Japan proposals on Wind tunnel method

April, 2018 WLTP IWG @ Ispra
Japan

ANALYSIS OF JP PROPOSAL ON CD*A DETERMINATION

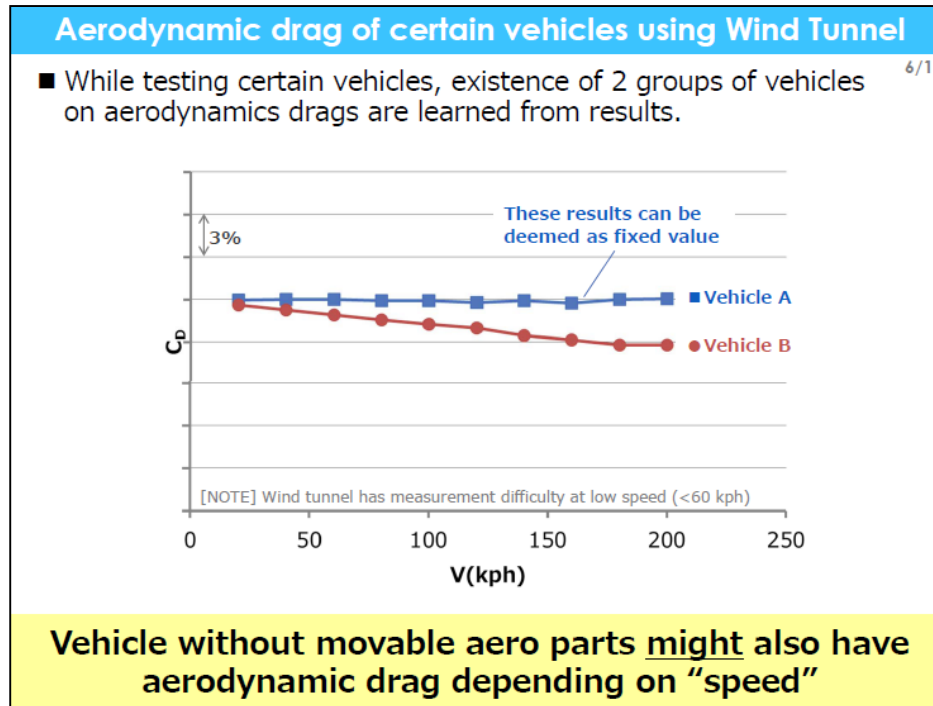
Works in WLTP for H, L and ind?

Works with moveable body parts?

Works in NEDC correlated in EU?

- (1.) Measuring at two wind speeds is supported.
- (2.) The procedure how to use that results cannot be supported, as it does not work under all conditions within the regulation (EU) and with all different technologies available on vehicles (moveable aerodynamic body parts).
- Way forward: It is proposed to determine a (weighted?) average of the cd^*A value and use only one value. Additionally there should be the option to use the value of the higher wind speed, if the value of the lower wind speed is within the WLTP tolerance for cd^*A (0.015 m^2).

Works for the determination of f_{0f1f2} for H and L, as they are anyway calculated by each speed point. "ind" not affected, therefore OK as well.

This needs the possibility to weigh cd^*A values after the Type I test including a different application in the family.

This is not an ECE issue. But it is necessary to keep WLTP applicable in Europe. The NEDC procedure needs one defined cd^*A value.
